D3 / Part A / Section A Introduction

- 2 This submission (Part A of my deadline D3 submissions) provides my comments on the “Applicant’s Response to Deadline 1 Submissions” [REP2-019].
- 3 I have used an AI tool to assist with drafting and refining the textual content of submissions to the examination for clarity and presentation. A full statement¹ on the use of AI is provided at Section G of my Part A Written Representation (D1 Part A submission, [REP1-077]).

**Figure 1: Future Energy Scenarios (FES), Figure 68 reproduced
“Gas supply mix by pathway”**

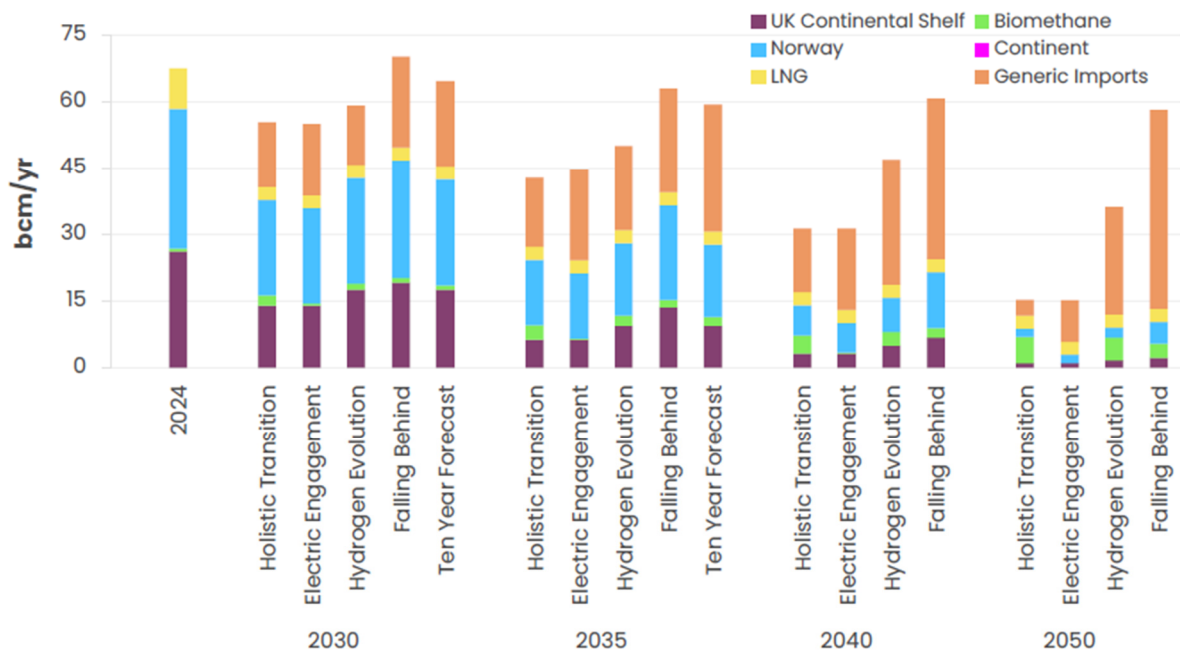
33 In FES 2025 Figure 68, Norwegian pipeline volumes remain a substantial component across scenarios, and NESO also shows an explicit minimum LNG stream. FES includes a further residual category, “Generic Imports”, which NESO describes as a balancing item that may comprise LNG and/or continental pipeline imports. The key point is that Figure 68 is that the real-world dynamics of gas supply under stress (for example, where weather conditions constrain the share of renewables on the grid) leaves the composition of “Generic Imports” contingent on market and system conditions.

34 The FES documentation explains that the model balances supply and demand by allocating UKCS first, then Norwegian pipeline, then minimum LNG and minimum continental/interconnector flows, with residual demand met through “Generic Imports”¹⁵. Accordingly, the LNG shown separately in Figure 68 (i.e. the yellow bars above) is not a cap on LNG in the system: LNG also contributes share within “Generic Imports” depending on market outcomes—particularly where continental pipeline availability is constrained and flexible cargoes clear at the margin.

- 36 Figure 68 from the Future Energy Scenarios (FES) uses four different NESO scenarios¹⁶ “Holistic Transition”, “Electric Engagement”, “Hydrogen Evolution”, “Falling Behind”, and a Ten Year Forecast (10YF)¹⁷. Figure 68 captures snapshots of the natural gas allocation for 2024 (essentially the same data as the NSTA data above), and then projections for each scenario in 2030, 2035, 2040 and 2050. The data table behind Figure 68 is reproduced from the FES 2025 Data Workbook in Appendix A along with the full graphs for each scenario.

- 37 In 2024, NSTA data (as reproduced in Figure 68) indicate that non-Norwegian continental pipeline imports were negligible (approximately 1 mboe), and that residual imports beyond Norwegian pipeline supply were overwhelmingly LNG. The data table in Appendix A shows that NESO project a minimum of 2.92 bcm/yr of LNG (the yellow bar); however in 2024, the actual LNG imports were 9.2 bcm/yr. This demonstrates that, in practice, where Norwegian and domestic production were insufficient in 2024, residual imports were overwhelmingly LNG. It illustrates how LNG operates as a major flexible balancing source. Figure 68 and the graphs reproduced in Appendix A show that this role is set to increase over time, as UKCS and Norwegian supplies decrease.

Figure 3: IPCC AR6 WGI SPM Figure SPM.2 reproduced

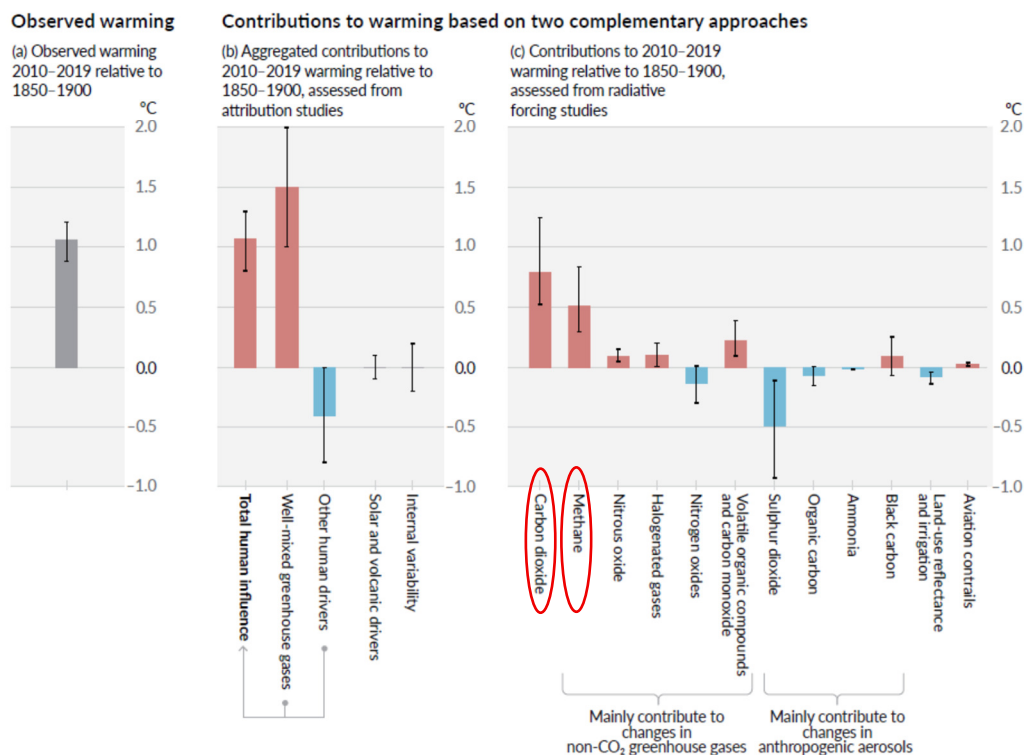
- 158 IPCC AR6 WGI Summary for Policymakers^{49,50} Figure SPM.2 attributes approximately 0.5°C of the 1.07°C observed anthropogenic warming (2010–2019 relative to 1850–1900) to methane — that is, on the order of one third of the total anthropogenic warming presented in the figure. Figure SPM2.2 is reproduced in Appendix C. AR6 further explains that methane’s shorter atmospheric lifetime results in a substantially greater warming effect when evaluated over a 20-year horizon than under a 100-year horizon. The AR6 mitigation assessment further explains that changes in short-lived climate forcers such as methane dominate the warming response in the near term and that reductions in methane concentrations can drive down near-term non-CO₂ warming before net zero CO₂ is reached.

Figure 4: IPCC AR6 WGI Figure 6.16 reproduced

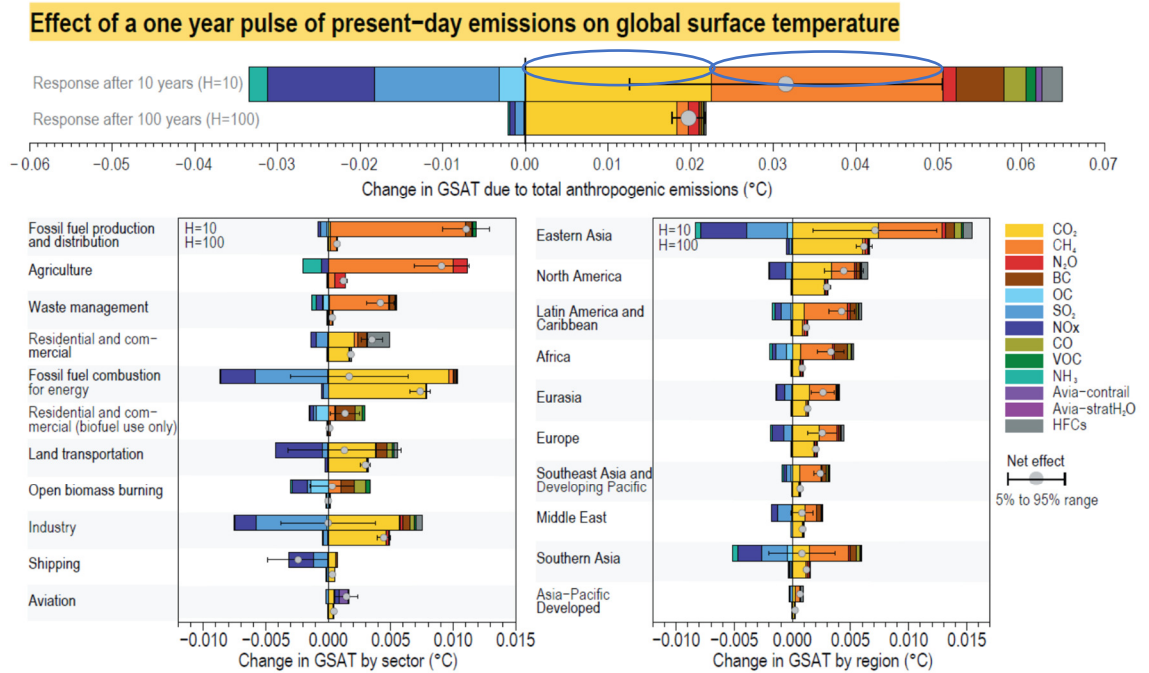
- 159 AR6 WGI Figure 6.16 (see stand-alone Appendix) identifies methane as a dominant short-lived climate forcer whose total current emission levels⁵¹ induce warming on 10–20 year time scales at least as large as total current emission levels of CO₂ emissions⁵². Figure 6.16 is reproduced in Appendix D, and shows that a one-year pulse of current emissions (“current” is 2014) produces a global mean temperature response of 0.022 °C for CO₂ and 0.029°C for methane i.e. current levels of methane emissions cause a greater temperature rise after 10 years than current levels of CO₂ emissions.
